**Florida Department of Transportation****RON DESANTIS**
GOVERNOR3400 West Commercial Boulevard
Fort Lauderdale, FL 33309**JARED W. PERDUE, P.E.**
SECRETARY

RE: Variance Committee Review to allow for **Category F Driveway****Applicant/Property Owner:** ACME Improvement District**Palm Beach County City of Wellington State Road: 7 Section: 93210000 MP: 21.1****Access Class: 03 Posted Speed: 50 mph SIS: N/A****Site Acreage: 70 Acres Development Size: 15 Multifamily Residential DU (Low-Rise); 180 Room Hotel; 1,750 Student Private School (K-12); 80,000 SF Office; 285,000 SF Shopping Plaza (Including +/- 80,000 SF Restaurant; 31,396 SF Church (existing))****Project Name & Address: K-Park - 10400 Stribling Way****AMRC Meeting Date: 9/4/2025, 11:15 AM****Request:**

Bryan Kelley – K-Park Access Management Review Committee Letter

K PARK
SECTION 24, TOWNSHIP 44S, RANGE 41E,
VILLAGE OF WELLINGTON, FLORIDA
DRIVEWAY ENTRANCE MODIFICATION EXHIBIT

OPTION 2G
FULL TRAFFIC SIGNAL
W/ INTERNAL ROUNDABOUT

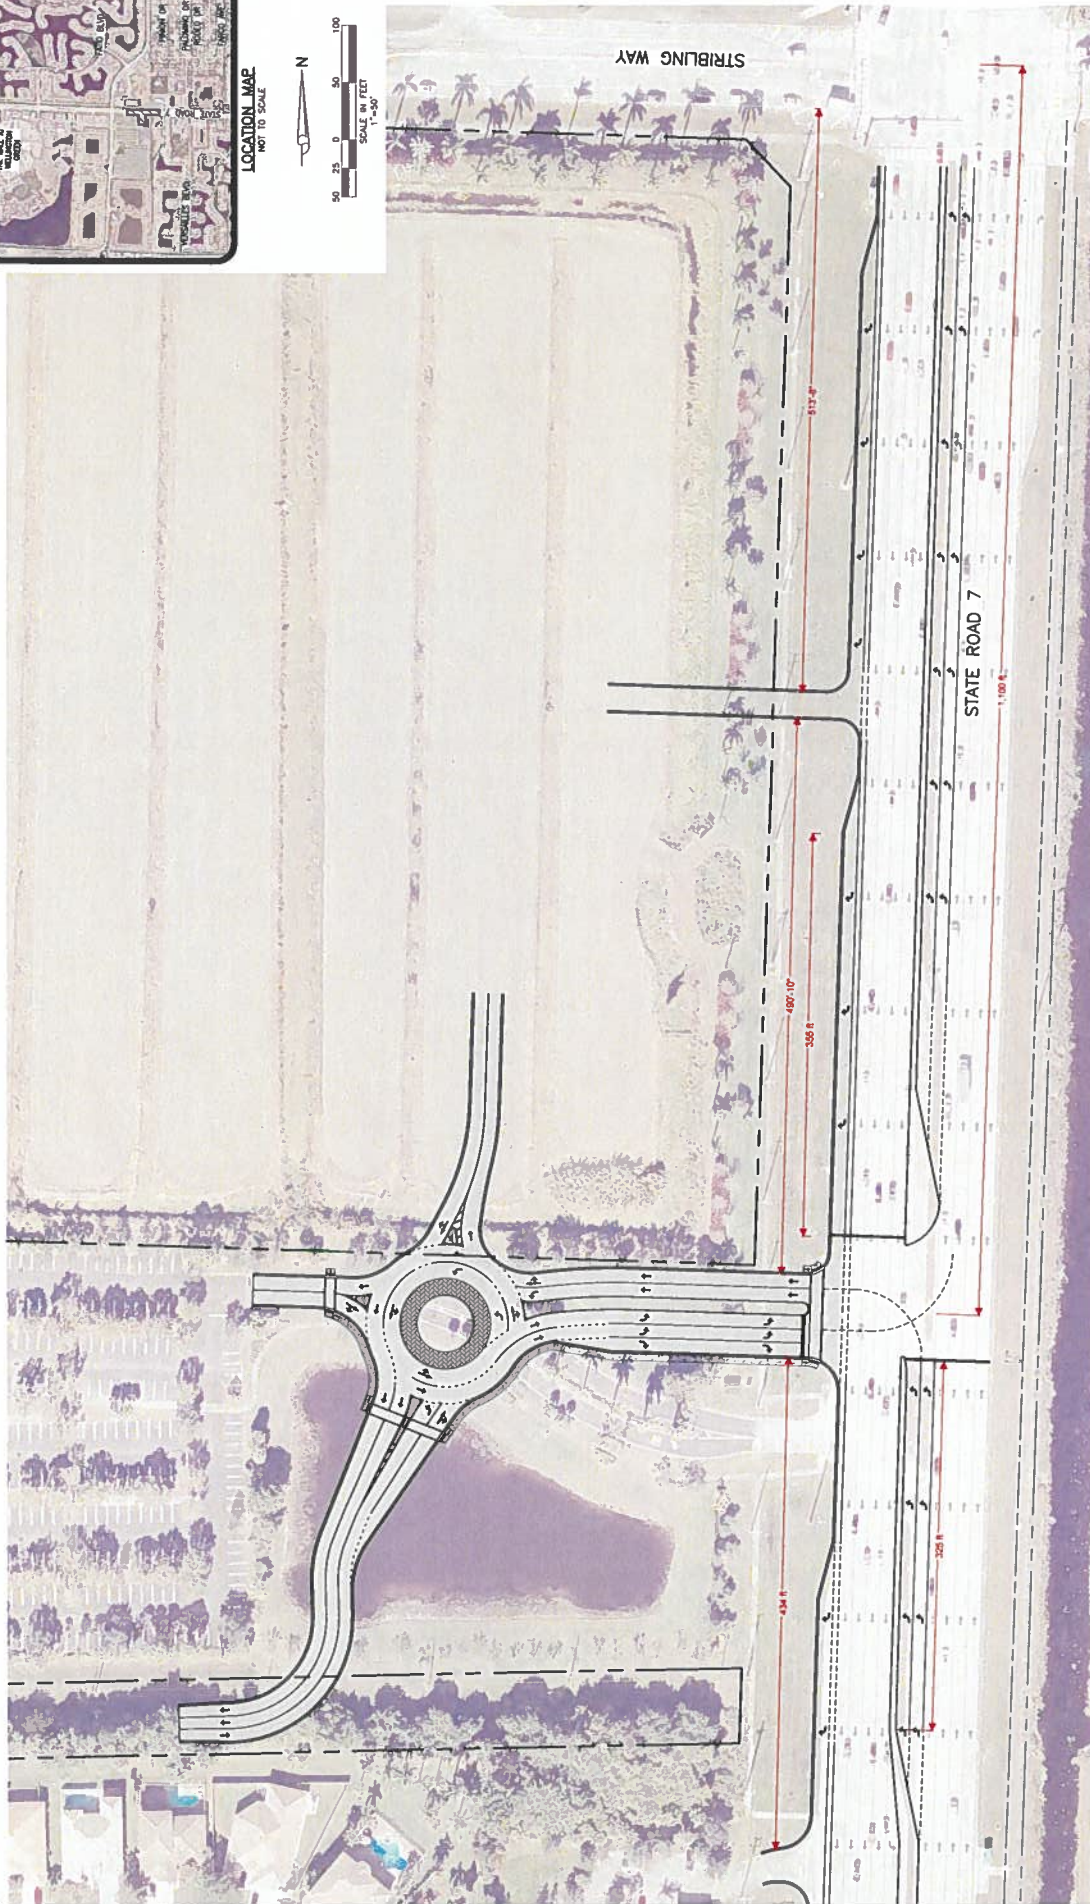
- **Driveway 1:** Proposed right-in/right-out driveway with right turn lane on the west side of SR 7, located approximately 514 feet south of Stribling Way.
- **Driveway 2:** Proposed signalized intersection on SR 7, located approximately 1,029 feet south of Stribling Way.
- Close the existing right-in/right-out/left-in driveway on the west side of SR 7, located approximately 1,153 feet south of Stribling Way.
- Remove the existing directional median opening on SR 7, located approximately 1,029 feet south of Stribling Way.

- ☐ Driveway 1 shall have a minimum driveway length of 100 feet, measured from the ultimate right-of-way line to the first conflict point in the driveway.
- ☐ The proposed signalized intersection (Driveway 2) shall have a minimum driveway length determined by a traffic study conducted by the applicant.
- ☐ The proposed multilane roundabout shall follow nationwide design guidelines (FDOT FDM Chapter 213). Queuing from the multilane roundabout's eastern approach must not encroach onto SR 7, as determined by a traffic study conducted by the applicant at permit.
- ☐ Right turn lanes are required for Driveways 1 & 2 and shall meet the minimum requirements in the Florida Design Manual (FDM) and shall provide space for a buffered bicycle lane.

- ☐ The queue length for the proposed northbound dual left turn lanes at Driveway 2 and the proposed dual northbound left turn lanes at the intersection of SR 7 and Stribling Way, must be determined by a traffic study conducted by the applicant at permit.

- ☐ An Intersection Control Evaluation (ICE) Analysis conducted by the applicant at permit, is required for Driveway 2.
 - ☐ The proposed traffic signal support system shall have the structural capacity to implement a minimum of one signal head per lane with five section heads for all three approaches, as needed.

- ☐ The following off-site improvements shall be implemented at the intersection of SR 7 & Stribling Way, by the applicant:
 - An additional northbound left turn lane. The intersection shall be served by dual northbound lefts.

- An additional eastbound right turn lane.
 - An additional eastbound left turn lane.
 - Extend the southbound right turn lane to meet minimum length as determined by a traffic study conducted by the applicant at permit.

- All existing driveways not approved in this letter must be fully removed and the area restored.
 - Additional right-of-way must be donated to the Department to implement the proposed improvements and mitigation, as needed.
